**ADDENDUM NO. 3
for
REQUEST FOR PROPOSALS
TRANSIT VEHICLE PROVIDER
for
CITY OF GRAND ISLAND, NEBRASKA**

October 5, 2021

RE: Questions

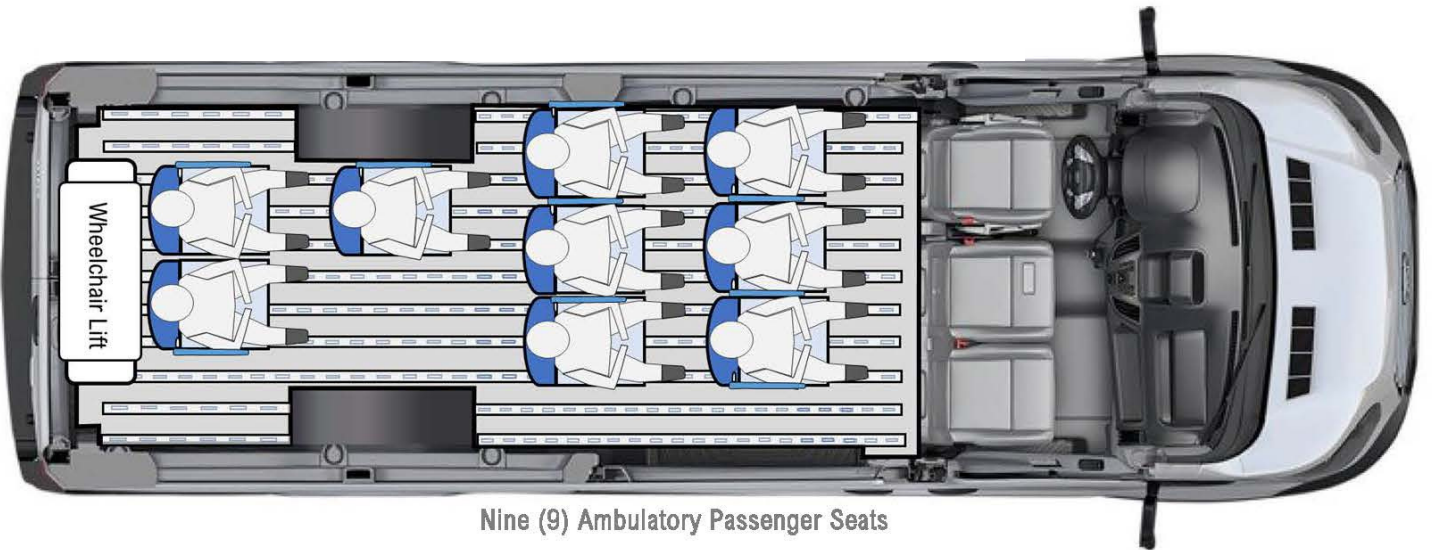
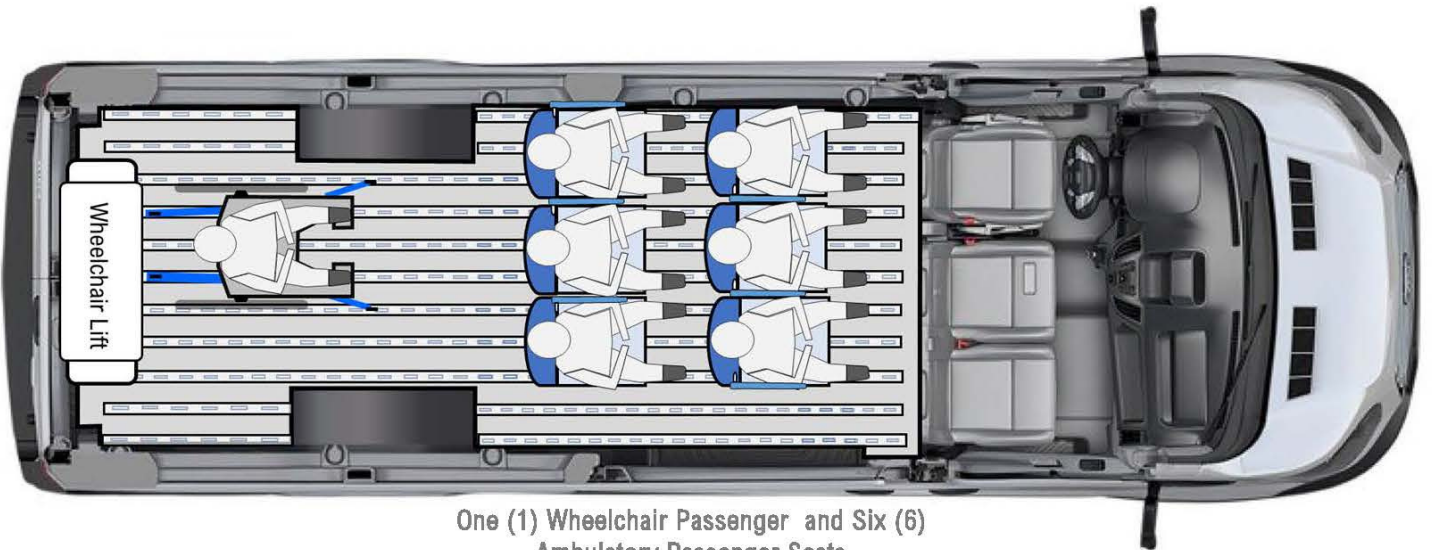
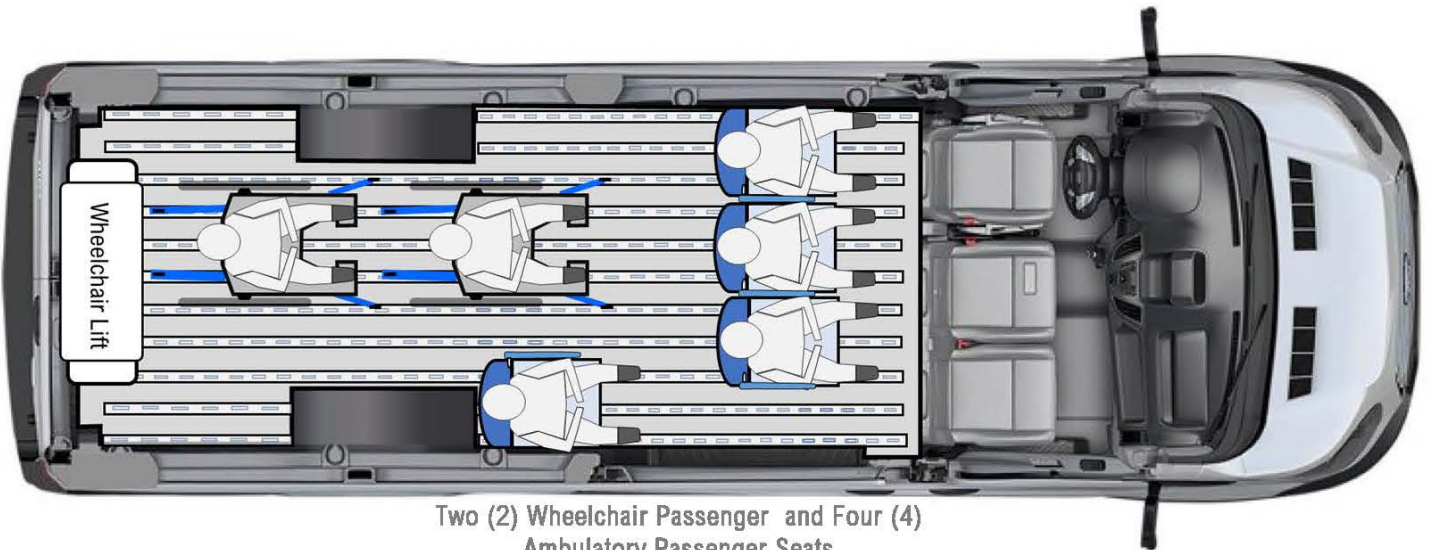
Please provide the Preferred Floorplan referenced as Appendix V to this RFP.

Page 10 B – states you want a 6+1 and page 15 J - states you want 9 passenger seats. Please clarify what is wanted.

Attached, apologies for it being omitted.

Please see Section F on Page 12. The request is for Modular Track flooring, which allows for a number of configurations. Nine (9) passenger seats and two (2) wheelchair securement systems should be included in pricing for each vehicle to allow for all configurations.

Vehicle seats must be able to be configured by Owner in multiple arrangements
